Panigale V4 S/STD MY 2020 (all versions)
Panigale V4 R MY 2019-2020 (all versions)
Technical Service Bulletin SRV-TSB-20-012

Date: November 5, 2020

Part 1: Replacement of the Hirschmann Gear Position Sensor

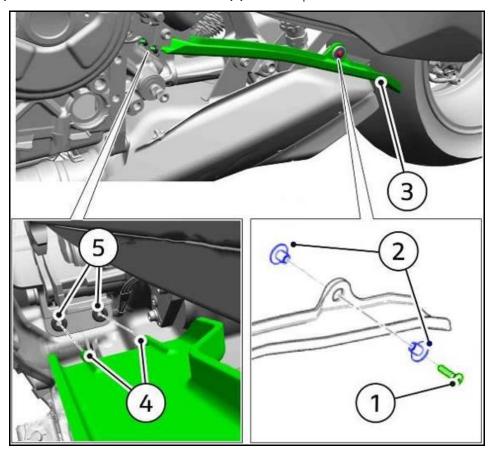
- 1. Remove the LH lower half-fairing (see Sec. 5: "Fairing installation Fairing" of the Workshop Manual)
- 2. Remove the M5x20 screw (1) and the 2 spacers (2) retaining the splash guard (3)
- 3. Slide the **splash guard (3)** out towards the rear side of the bike in order to release the **2 pins (4)** from the relevant **rubber blocks (5)** on the sprocket cover

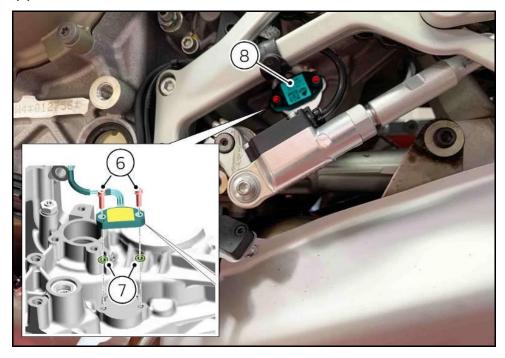
4. Remove the 2 M4x14 screws (6) and the relevant washers (7) 0.2mm thick securing gear sensor (8) to crankcase

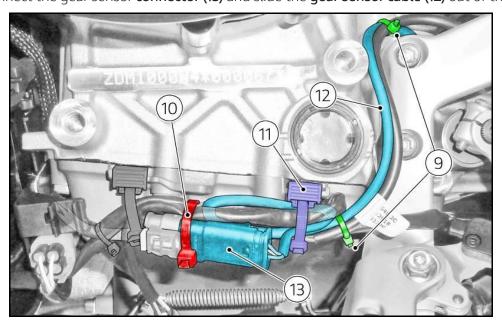
- 5. Remove the 2 small self-locking ties (9), the big self-locking tie (10) and the Hellermann clamp (11) to release the gear sensor cable (12)
- 6. Disconnect the gear sensor connector (13) and slide the gear sensor cable (12) out of the vehicle

- 7. Clean the 2 screws M4x14 to remove all previous threadlocker and take the new Hirschmann gear sensor (X) Part no.55243941A and the 2 washers (L) 1 mm thick from kit Part no.69929211A
- 8. Insert the 2 screws M4x14 (6) on gear sensor (X) and insert the 2 washers (L) on the screw thread, ON THE OTHER SIDE between engine case and sensor.
- 9. Apply LOCTITE 243 (or equivalent) on the thread of the 2 screws M4x14 (6)
- 10. Position Hirschmann gear sensor on the crankcase, start the 2 screws M4x14 (6) making sure that the label is visible, as shown in the figure. Tighten the screws to a torque of 2.5 Nm ± 10%
- 11. After tightening, remove any excess of threadlocker

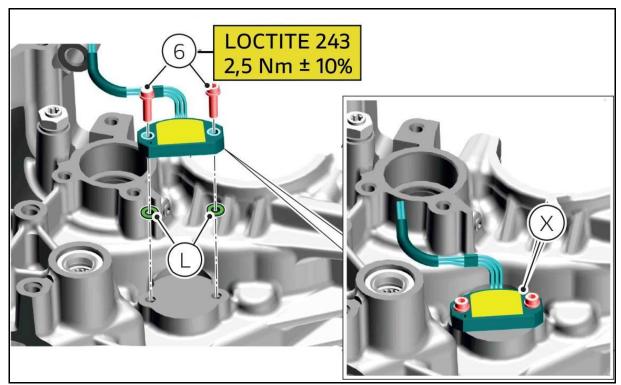
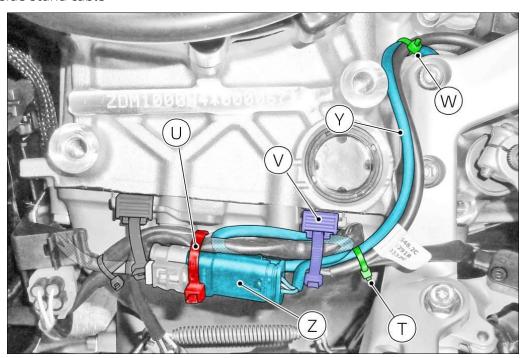
- **12.** Position **gear sensor cable (Y)** and secure it in place using the self-locking ties, as shown in the figure. In particular
 - Fit the new small self-locking tie (W) to fasten together gear sensor cable (Y) and Ducati Quick Shift cable
 - Fit the new small self-locking tie (T) to fasten together gear sensor cable (Y), Ducati Ouick Shift cable and side stand cable
 - Fit the new **Hellermann clamp (V)** to fasten together Ducati Quick Shift cable, front lambda sensor cable excess length, **gear sensor cable (Y)** with relevant excess length and side stand cable
 - Connect gear sensor connector (Z) and use the new big self-locking tie (U) to fasten it
 to Ducati Quick Shift wiring branch, front lambda sensor cable exceeding length and
 side stand cable

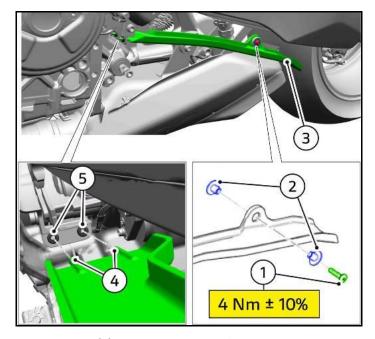
- 13. Install the splash guard (3) as shown in the figure by inserting the 2 pins (4) in the relevant seals (5) on the sprocket cover
- 14. Fit the 2 spacers (2) on the vibration damper on the splash guard (3)
- 15. Tighten the screw M5x20 (1) that retains the splash guard to the left silencer cover to $\frac{4}{100}$ Nm \pm 10%

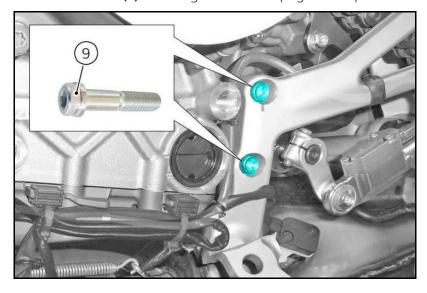
16. Remove the 2 screws M8x35 (9) securing the LH footpeg holder plate

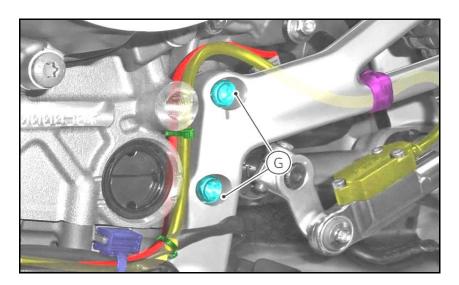
- 17. Take from the kit part no.69929211A the 2 special screws M8x35 (G), apply Shell Gadus S2 V220 AD 2 grease (or equivalent) and start them onto the LH footpeg holder plate (10)
- 18. Tighten the 2 special screws M8x35 (G) to 25 Nm ±5%

Make sure that the DQS sensor cable and the gear sensor cable do not overlap the 2 special screws M8x35 (G), and are not pinched between the foot holder plate and the engine case.

Part 2: Installation of the Air Conveyer

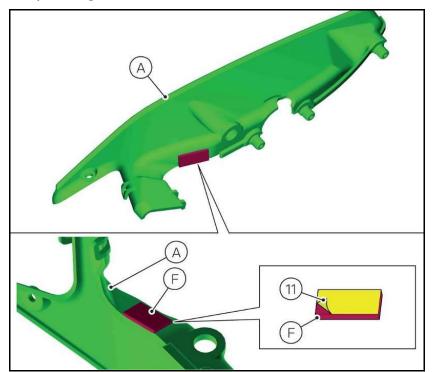
- 1. Take the following parts from the part no.69929211A
 - upper conveyor (A)
 - lower conveyor (B)
 - adhesive pad (F)
 - 4 self-tapping screws (H)
- 2. Remove protective film (11) on the back of the adhesive pad (F)
- **3.** Apply adhesive **pad (F)** in the indicated area of **upper air conveyor (A)** positioning it as shown in the figure.

Before applying the adhesive pad, thoroughly clean the upper conveyor surface where pad will be stuck. During the application, take special care not to touch the adhesive surface with your fingers.

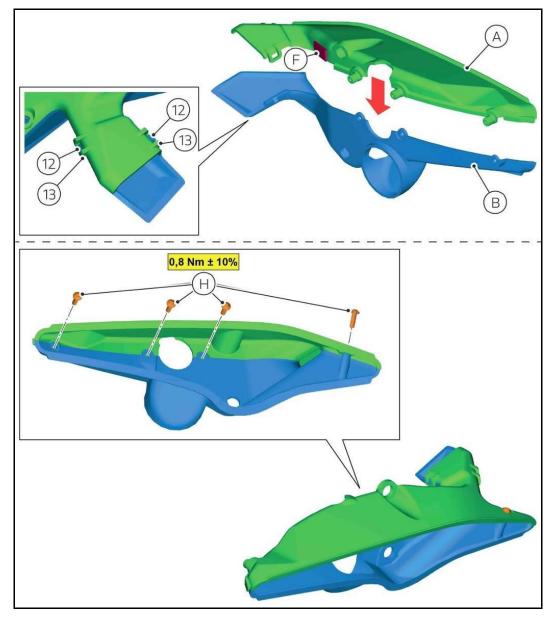
- 4. Fit upper conveyor (A) on lower conveyor (B), making sure that the 2 teeth (12) are correctly inserted inside the 2 ends (13) and start 4 self-tapping screws (H)
- 5. Tighten the 4 self-tapping screws (H) to 0.8 Nm ± 10%

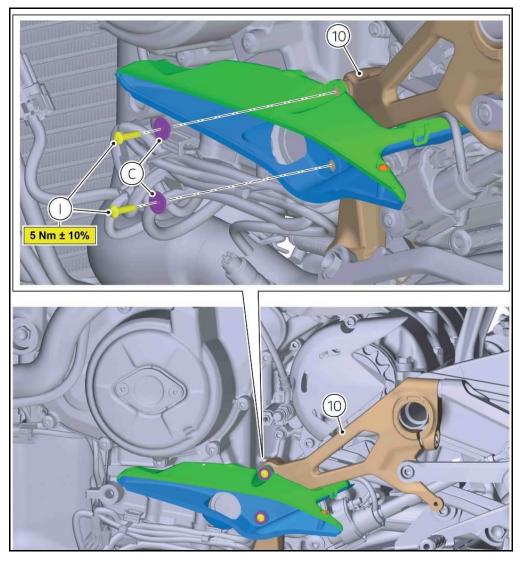
- **6.** Take the **2 screws M4x16 (I)** and the **2 spacers with collar (C)** from the kit part no. 69929211A
- 7. Fit no. 2 spacers with collar (C) on the thread of no. 2 screws M4x16 (I)
- 8. Position the air conveyor assembly on LH footpeg holder plate (10), aiming it as shown in the figure and start no. 2 screws M4x16 (I)
- 9. Tighten the 2 M4x16 screws (I) to 5 Nm ± 10%
